## #2018-12 Mercyhealth Hospital Project Review for Planning and Zoning Commission

<b><u>Meeting Date:</u></b>	March 21, 2018
<b><u>Requests:</u></b>	Final Planned Unit Development for a hospital and medical offices and Variations.
<b><u>Location:</u></b>	875 Route 31
<b><u>Acreage:</u></b>	16.39 acres
<b><u>Existing Zoning:</u></b>	O PUD Office
<b><u>Surrounding Properties:</u></b>	North: B-2 PUD General Commercial South: M Manufacturing East: M Manufacturing West: M Manufacturing
<b><u>Staff Contact:</u></b>	Elizabeth Maxwell (815.356.3615)

# EXHIBIT A

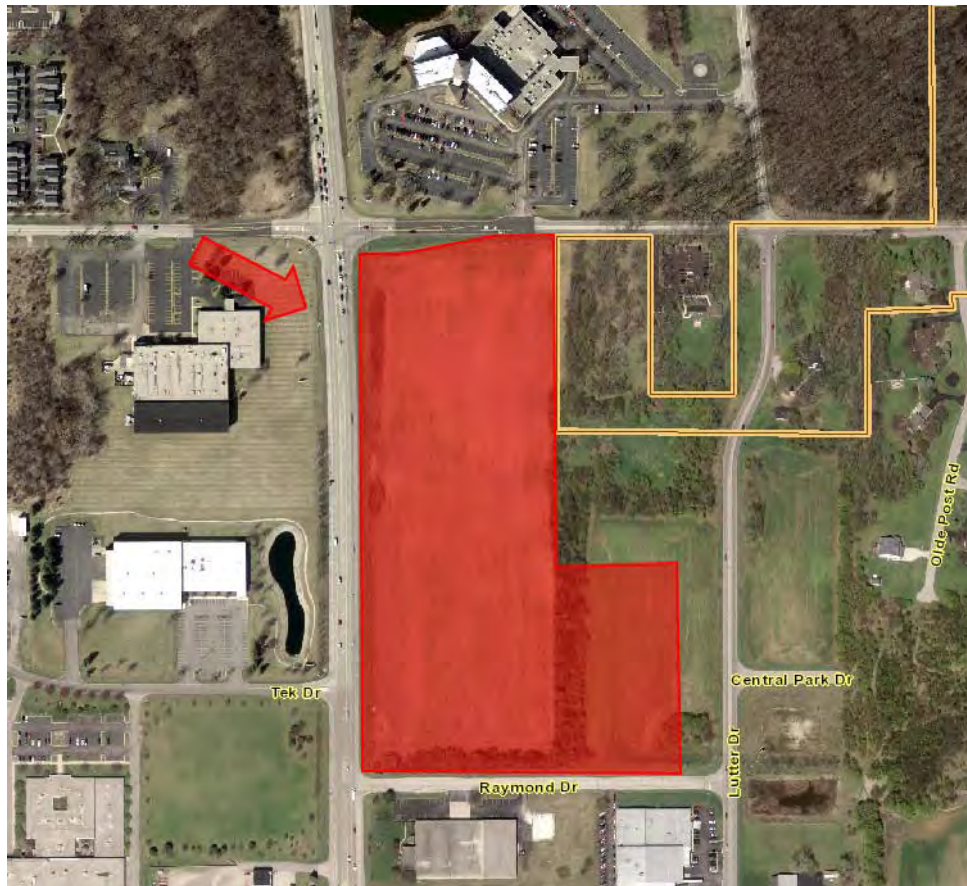
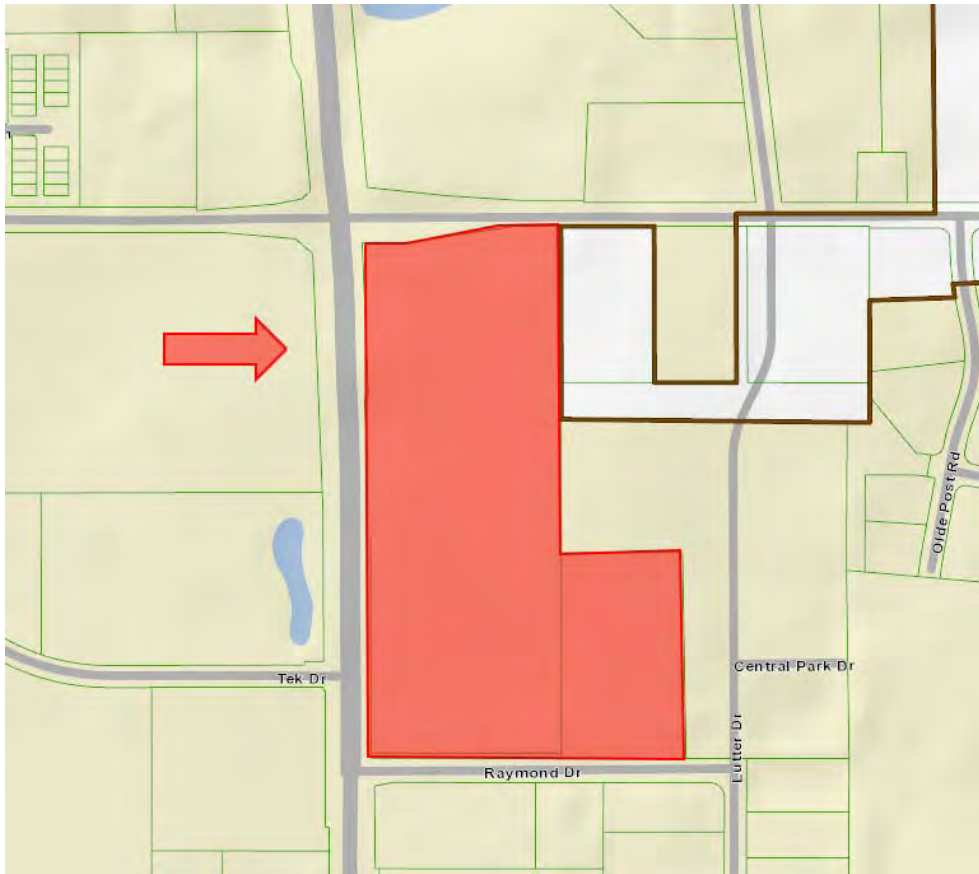
Install roundabout.  
Right-of-way may be  
required at the northwest  
and northeast corners.

Install a new traffic signal and appropriate equipment; interconnect with existing traffic signal at Route 31
